2 Master Responses

This chapter presents responses to environmental issues raised in multiple comments. These have been termed “master responses.” They are organized by topic so that reviewers can readily locate all relevant information pertaining to an issue of concern.

2.2 Master Response 1: Delta Water Quality Analysis

Time Series of Salinity – Clifton Court Forebay (Existing and Future Conditions)

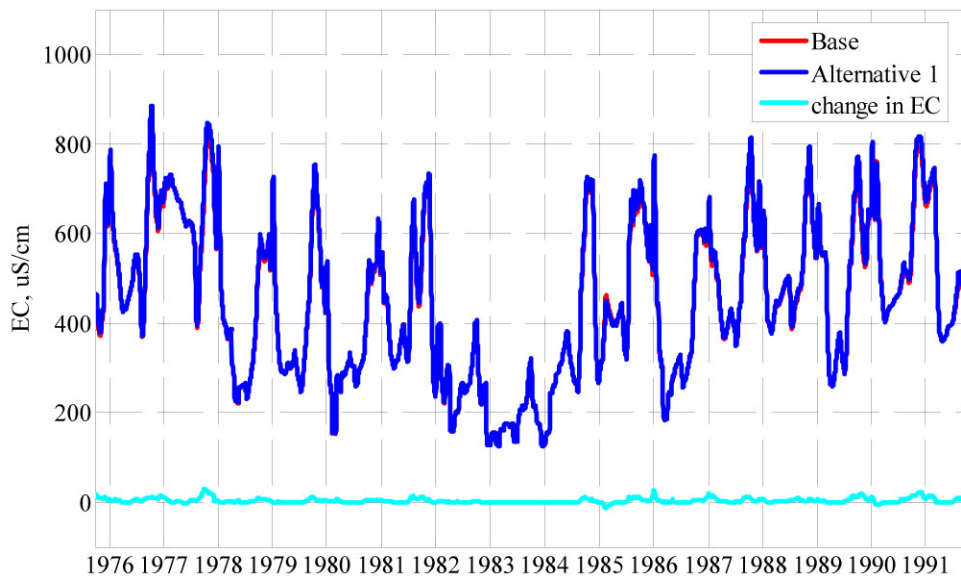
Several comments concerned the presentation and use of modeling results within the Alternative Intake Project Draft EIR/EIS. The Draft EIR/EIS presented annual and monthly water quality changes as summary information, with details on the results presented in Appendix C of the Draft EIR/EIS. All modeling data were provided to those who requested further information. Analysis for the Draft EIR/EIS involved evaluating model simulations of the project for the 16-year simulation period including maximum, minimum, and average changes to daily, monthly, and annual salinity. This information is provided in Appendix C-4, "DSM2 Delta Modeling," to the Draft EIR/EIS. The presentation of averages in the main text is not misleading because in the case of the Alternative Intake Project, the averages do not mask a bigger effect. The Alternative Intake Project's effect on water quality would be small at all times. This can be seen in the time series plots of daily salinity at different Delta locations over the 16-year modeling period (for example, Exhibit 4.2-9 from the Alternative Intake Project Draft EIR/EIS Volume I presented here shows daily data plotted over the entire 16-year period, and the salinity changes are barely discernable).

In addition to the detailed information provided in Appendix C-4, "DSM2 Delta Modeling," to the Draft EIR/EIS, complete modeling results were made available to several commenters in digital format, as they requested. In addition, CCWD and Reclamation worked closely with stakeholders to solicit their input and make materials available to them prior to and during the review period for the Draft EIR/EIS. Specifically, CCWD met with and briefed the Metropolitan Water District of Southern California (MWD) (October 2005 and January 2006), the State Water Contractors (SWC) (January 2006), Kern County Water Agency (KCWA) (April 2006), and the California Department of Water Resources (DWR) (April and June 2006) and made modeling results available in digital format so that they could be examined in detail. During the review period, several commenters requested electronic copies of the modeling results and were provided with a CD containing input and output for the operations (CALSIM and CCWD solver model) and hydrodynamic (DSM2) modeling used in the Draft EIR/EIS analyses. CCWD and Reclamation have provided all requested information. Full modeling data are included in CD format as Appendix B to this document so that all readers will have access to them.

EXHIBIT 2.8-1

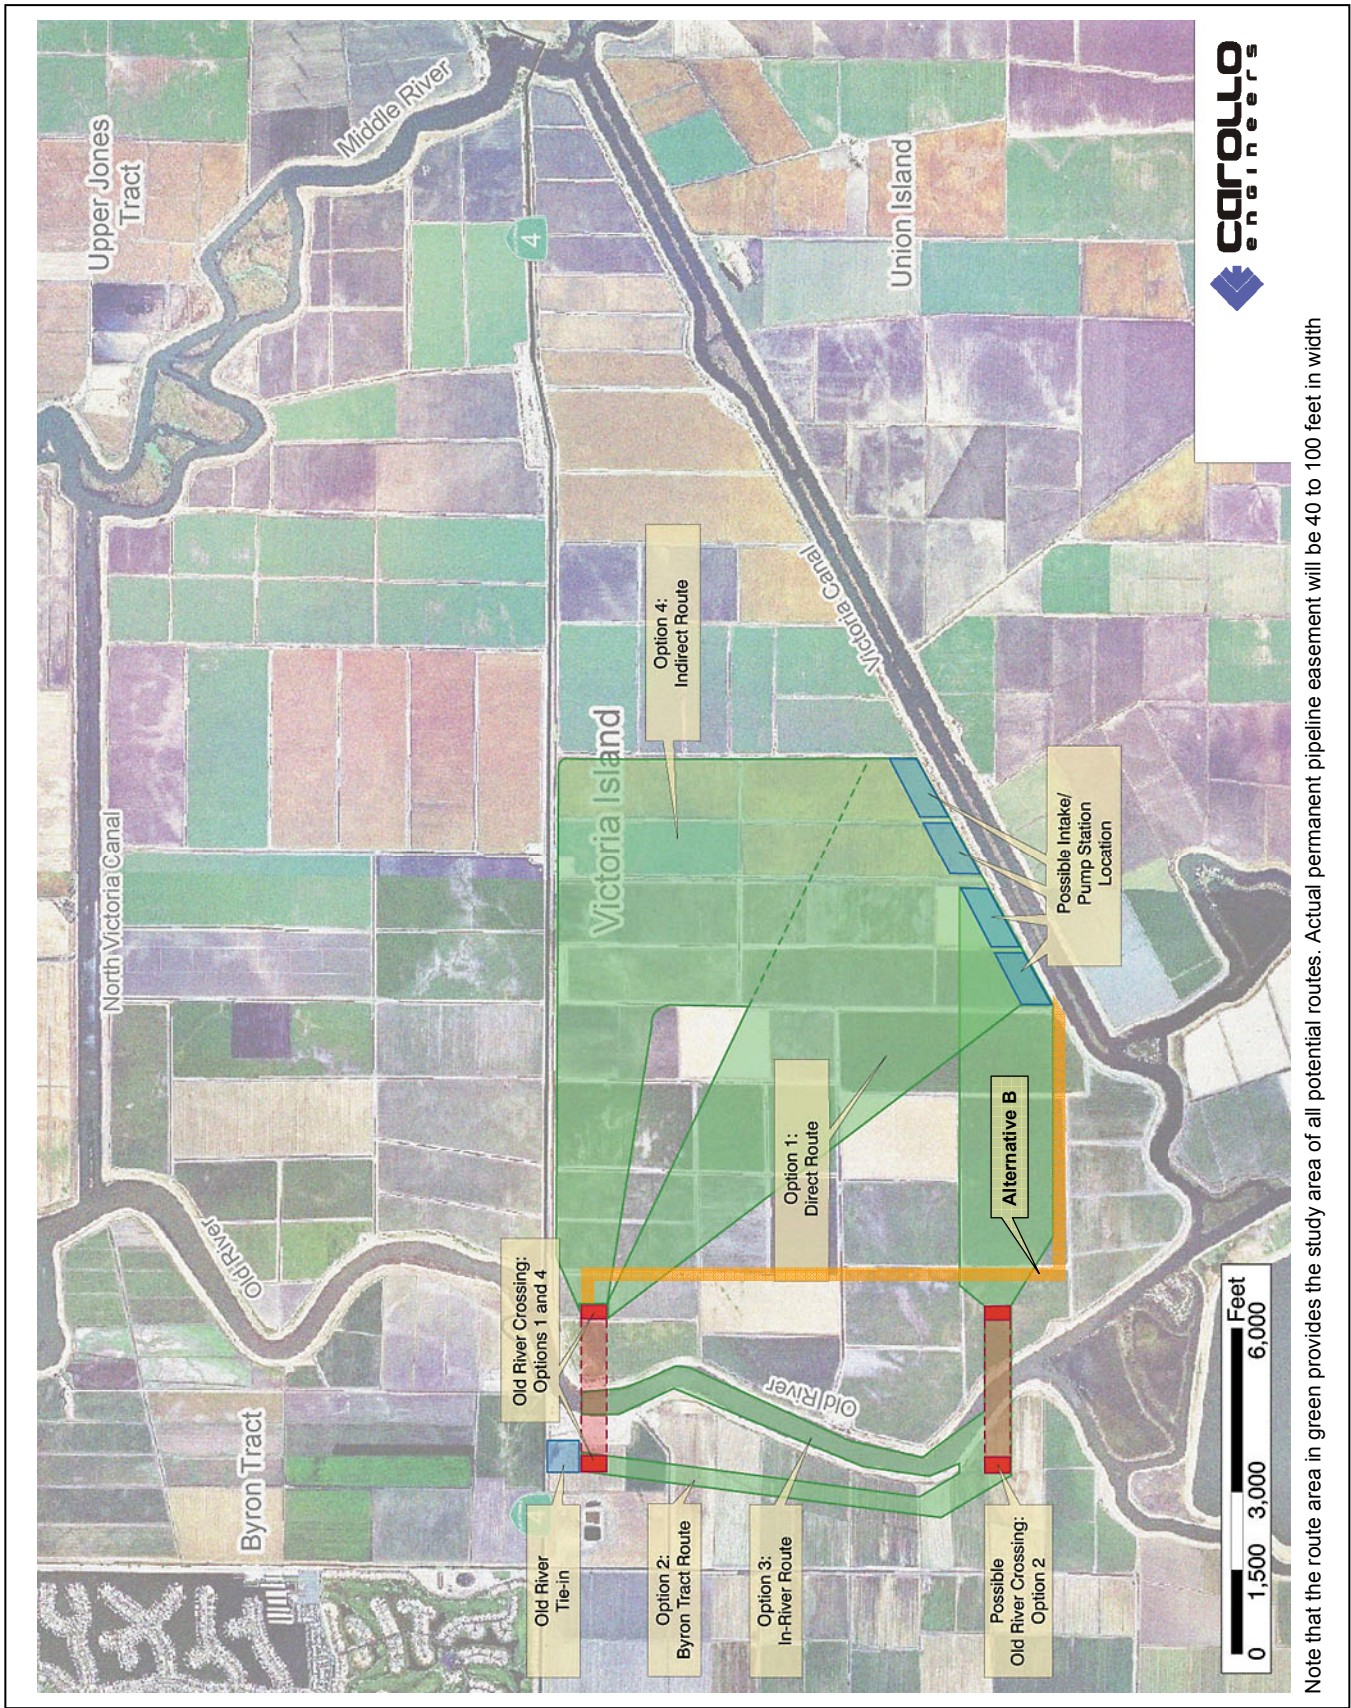
Several comments discussed the differences in potential impacts of the different pipeline alignments. Comments from CDWA/RD2040 suggested that additional alternative pipeline routes on Victoria Island should be considered. Several alternative pipeline alignments were examined during the alternatives screening process for the project, as discussed in Appendix B, “Alternatives Screening,” to the Draft EIR/EIS. Alternative 2, Indirect Pipeline Alternative, was developed in response to discussions with the landowner regarding the particular farming practices and preferences at this location. A number of different pipeline routes within the southwest quarter of Victoria Island were initially considered. The alternatives presented in the Draft EIR/EIS bracket the pipeline route options in terms of pipeline length, pipeline location, and potential environmental impacts. The impacts analysis conducted for the Draft EIR/EIS indicates that variations on these routes would not be materially different in terms of potential environmental impacts related to agriculture.

The letter from the CDWA/RD2040 suggests that two additional pipeline routes be examined. One falls within the corridor proposed for Alternative 2, Indirect Pipeline Alternative, and thus has already been analyzed in detail. The other, labeled “Alternative B” by the commenter, follows a westerly then northerly path across the island from the proposed new intake location. Both routes, as suggested by the commenter, are shown on Exhibits 2.8-1 and 2.8-2. They are superimposed on an exhibit that was included in Appendix B, “Alternatives Screening,” of the Draft EIR/EIS as an illustration of the potential routes examined.
